## ASSESSMENT REPORT

### Bengalla Coal Mine – Ancillary Infrastructure Changes (SSD 5170 MOD 1)

Figure 2: Project Layout and Proposed Modified Components

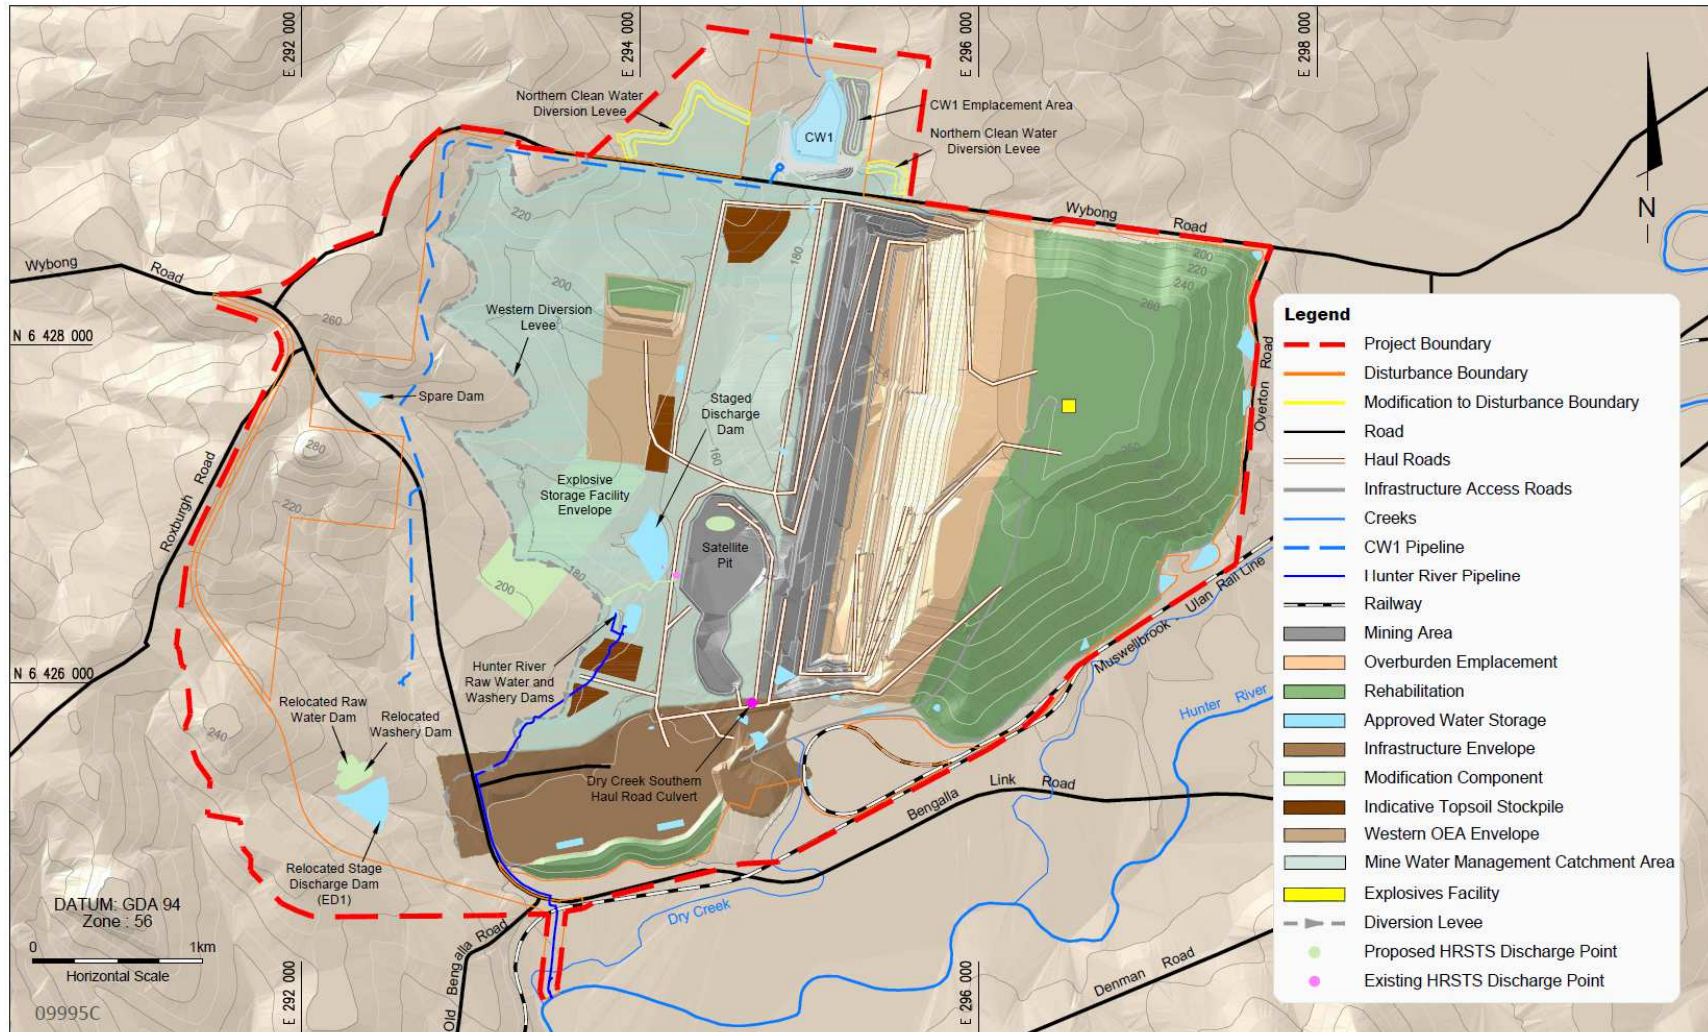
<i>Hazards</i>	<ul style="list-style-type: none"> <li>• Bengalla is seeking a changed location for its approved Explosives Storage Facility. The proposed location is not yet finally determined, but would be within a given 'envelope' or perimeter of land (see Figure 2). Bengalla does not propose any changes to the approved storage capacity, type or use of explosives.</li> <li>• The new facility would be constructed in accordance with AS 2187:1998 Explosives - Storage, Transport and Use – Storage and relevant NSW Occupational Health and Safety (OH&amp;S) regulations. Bengalla currently holds two licences to store explosives and associated materials, being 07-100151-001 and XSTR100151.</li> <li>• Bengalla states that the proposed Explosives Storage Facility Envelope would provide efficient and safe access by light and heavy vehicles by limiting travel through active open cut mining areas.</li> </ul>	<ul style="list-style-type: none"> <li>• No changed conditions required.</li> </ul>

Figure 3: Northern Diversion Levee and Vegetation Communities

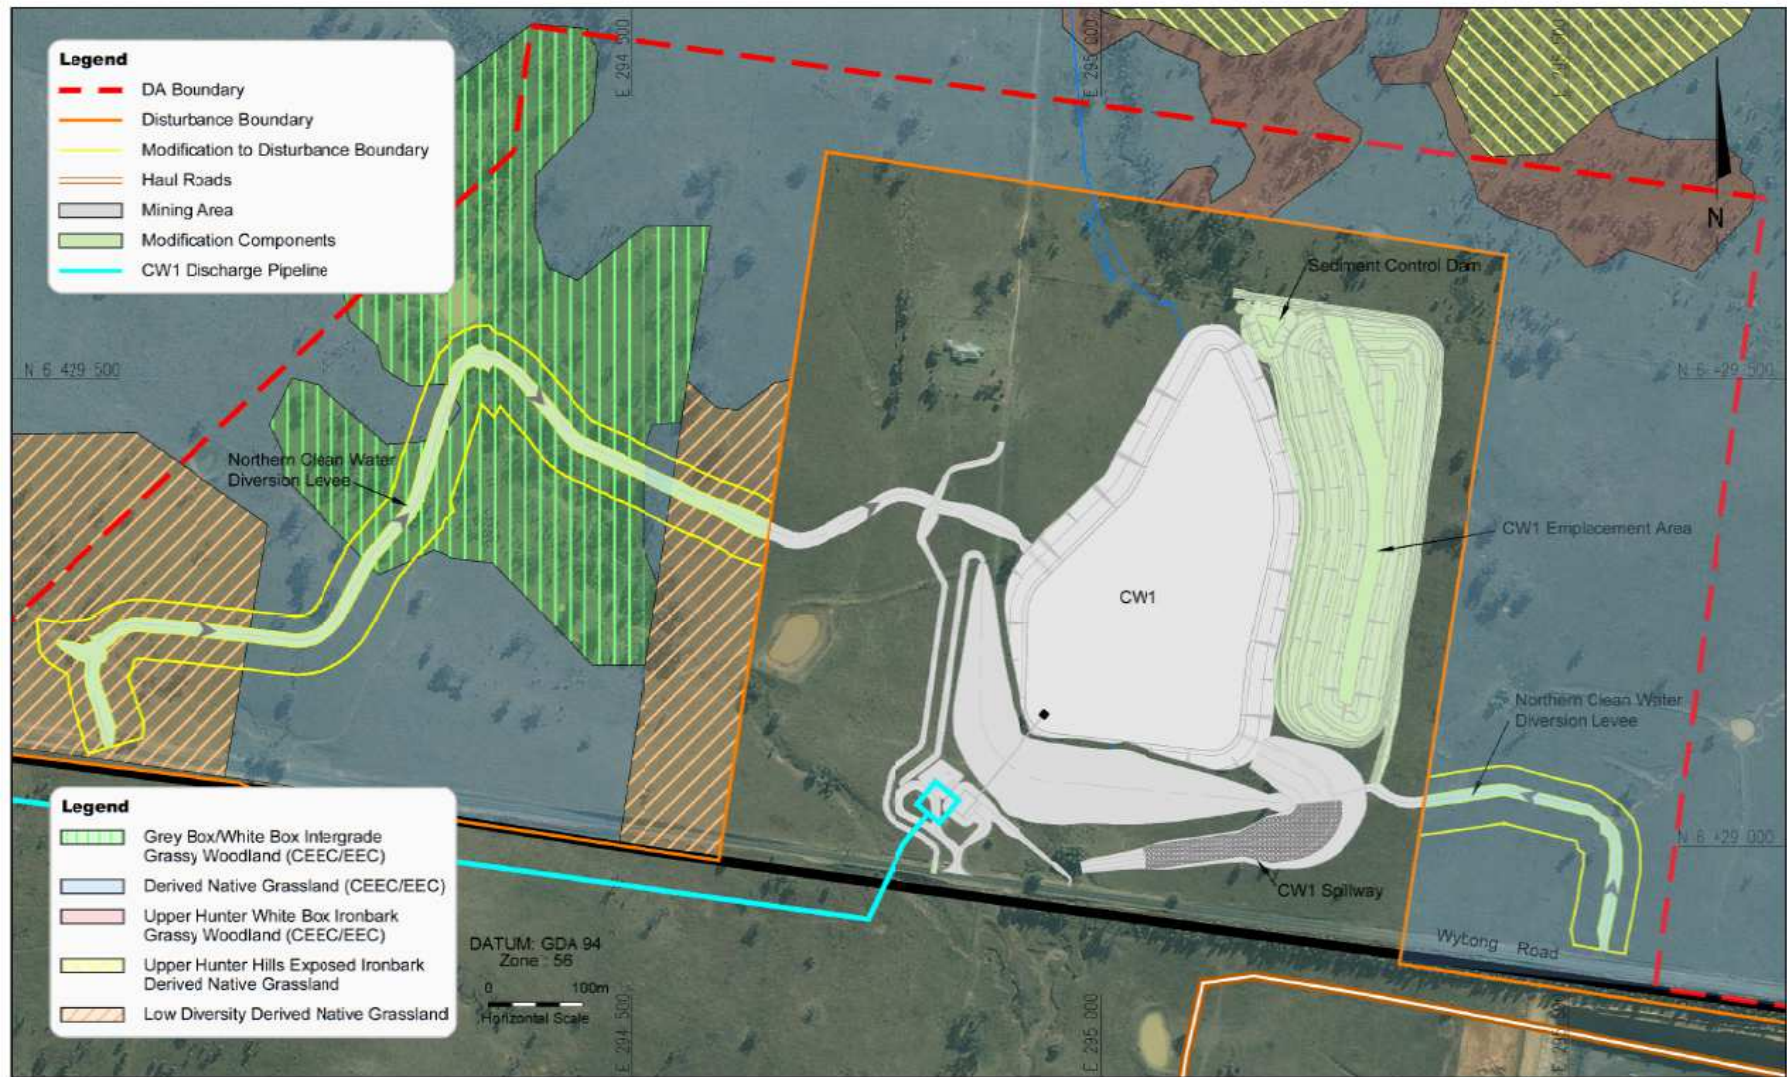
The SEE contained a specialist ecological impact assessment (EIA) undertaken by Cumberland Ecology. The EIA found that construction of the Northern Clean Water Diversion Levee associated with the water storage dam CW-1 would disturb vegetated land north of Wybong Road (see Figure 3). This area is currently used for cattle grazing and has had a long history of agricultural activities.

The EIA found that the proposed levee construction would permanently remove 1.24 ha of native vegetation consisting of 0.59 ha of *Grey Box/White Box Grassy Woodland EEC* and 0.65 of this community's derived native grassland (DNG). It would also remove 2.28 ha of non-native pasture.

Bengalla has conservatively assumed an indirect disturbance boundary around the levee and has included this in the total disturbance area. This 'buffer area' is where workers and machinery would operate during construction of the levee. This is an assumed maximum area and the actual area of disturbance is likely to be lower. Indirect disturbance in the buffer area would include 2.2 ha of *Grey Box/White Box Grassy Woodland EEC*, 2.61 ha of this community's DNG and 2.97 ha of non-native pastures.

The Department considers these measures are helpful in ensuring the proposed impact is acceptable. However, the Department has recommended additional conditions requiring that, during construction and maintenance of the Northern Diversion Levee, Bengalla must ensure that impacts to native vegetation (particularly EECs) are minimised as far as is reasonable and feasible, to the satisfaction of the Secretary.

**Figure 4: Mt Pleasant Coal Mine - Worst-case Infrastructure Scenario**

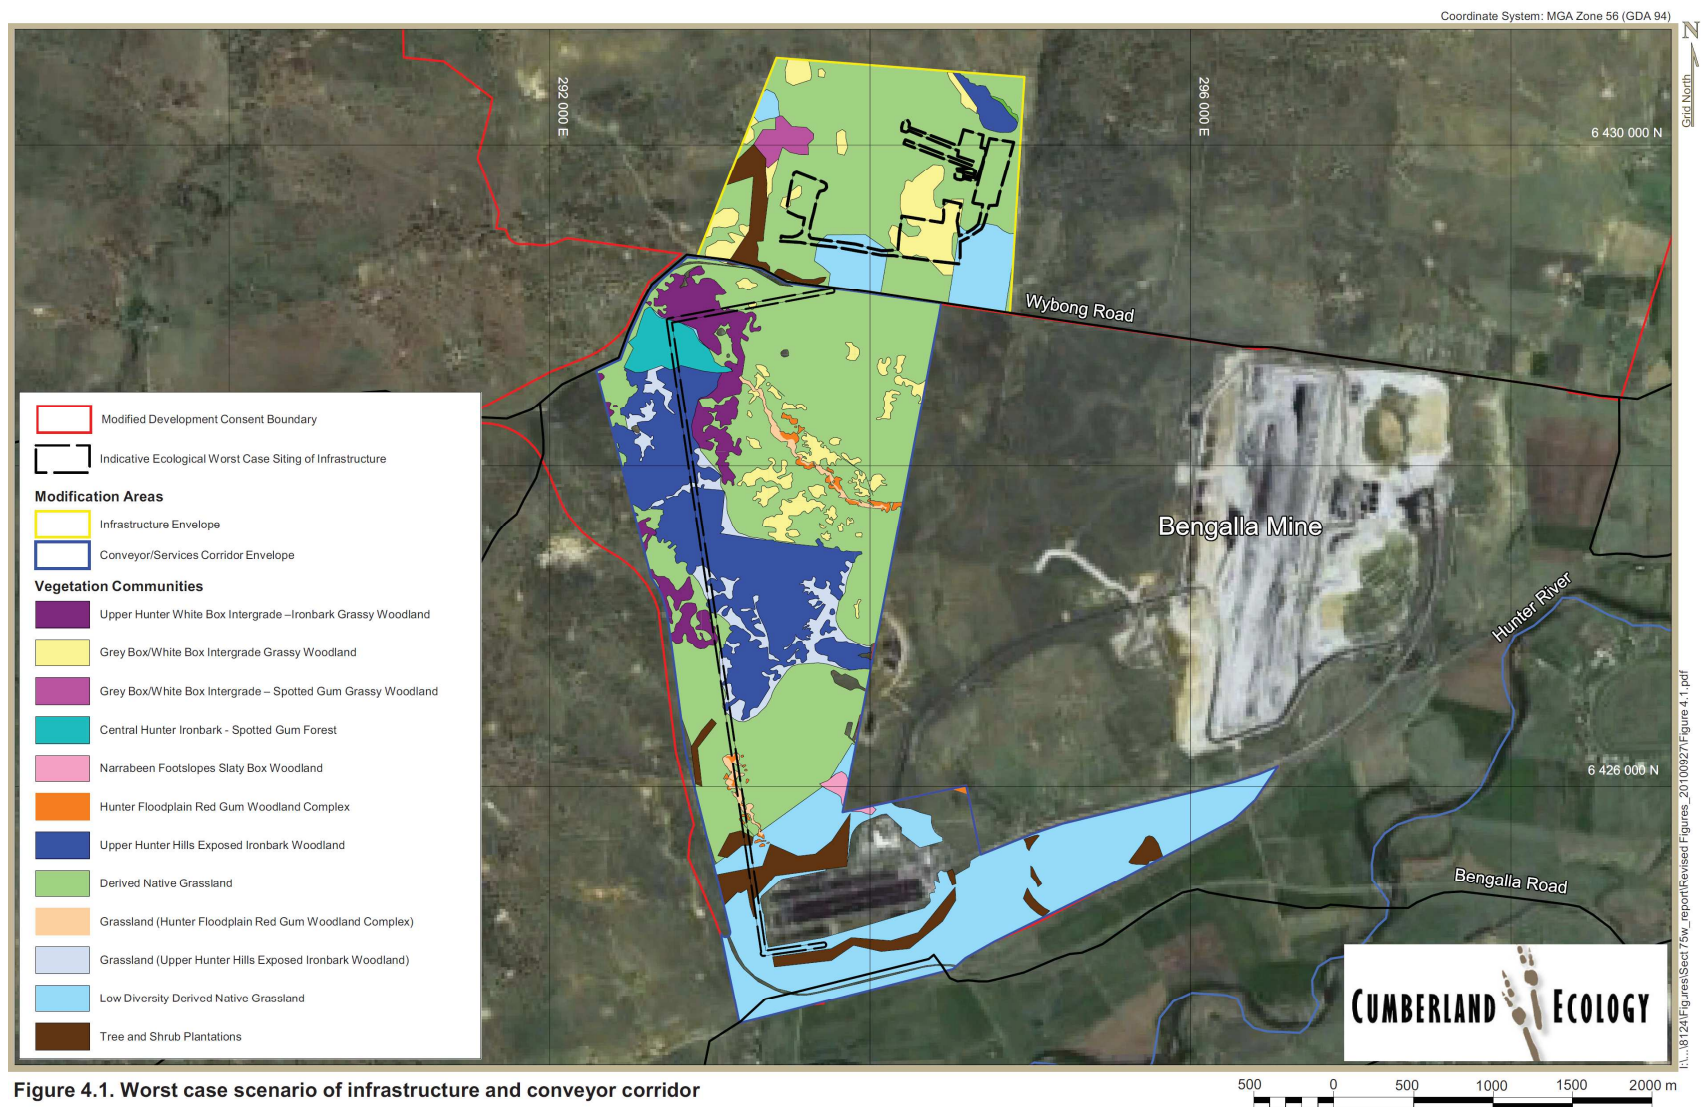
The Environmental Assessment for the 2011 modification to Mt Pleasant's development consent includes a vegetation map showing the worst-case scenario for vegetation clearing for project-related infrastructure (refer Figure 4). This figure shows that the approved processing infrastructure for the Mt Pleasant Coal Mine is located within the same area of box gum woodland and DNG as the eastern part of Bengalla's proposed Northern Clean Water Diversion Levee.

Consequently, this area of EEC woodland and part of the DNG is already approved for removal by the Mt Pleasant development consent. Also this vegetation was assessed and appropriately offset as part of the modification application by both the Department and the Commonwealth.
